CALN TOWNSHIP - CONDITIONAL USE HEARING AUGUST 27, 2020 THE WILLOWS AT VALLEY RUN – MBID OF DELAWARE LLC

APPLICANT'S EXHIBITS:

- A-17 Response Letter of D.L. Howell & Associates, Inc. to Review Letter of ARRO
- A-18 CV of Daniel Magno from Haley Donovan
- A-19 Notification Letter with Property Owner Information within 500 ft

CONDITIONAL USE PLAN THE WILLOWS AT VALLEY RUN CALN TOWNSHIP, CHESTER COUNTY

# ERNST - Rain Garden Mix (ERNMX-180)

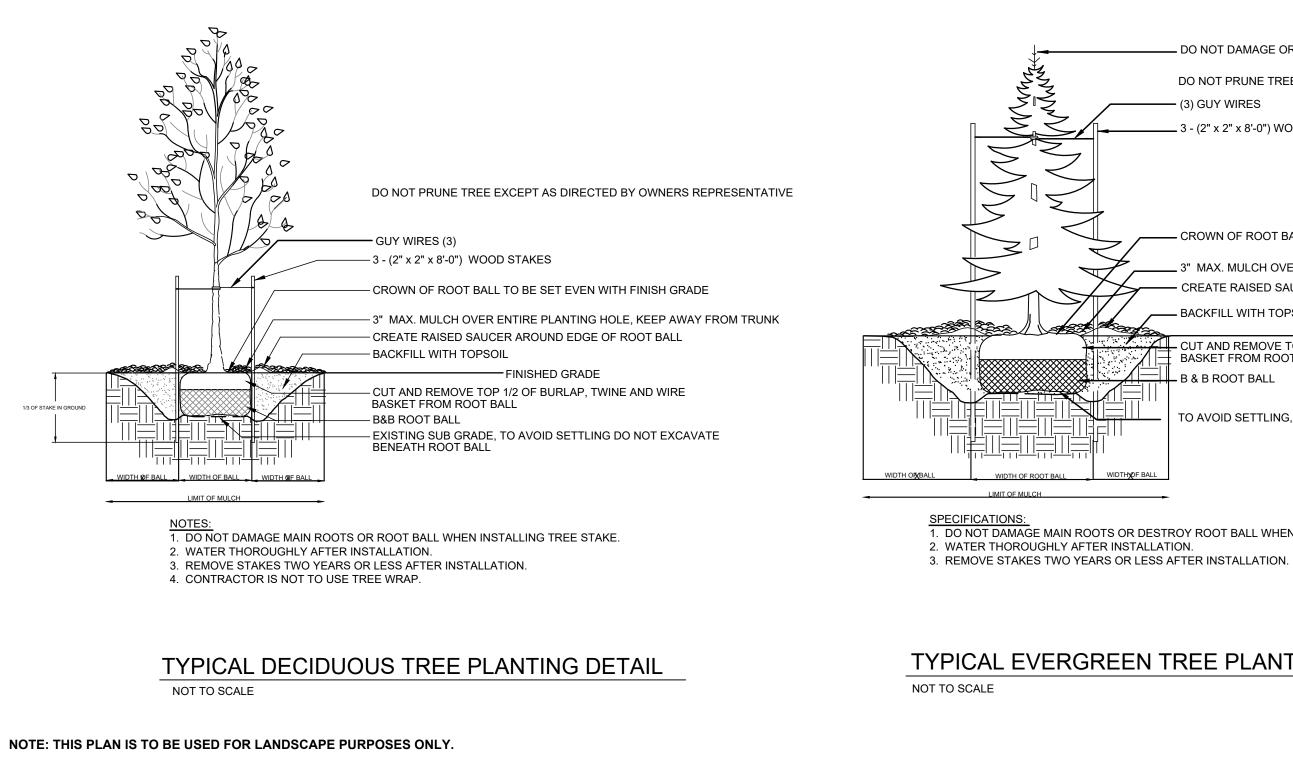
The plant list on sheet 6 must be revised to meet the approved plant/tree species of this section.

## <u>Response: The Landscape Plans have been updated accordingly, see Drawings C07.1 and C07.2, Sheets 07 and 08 of 08.</u>
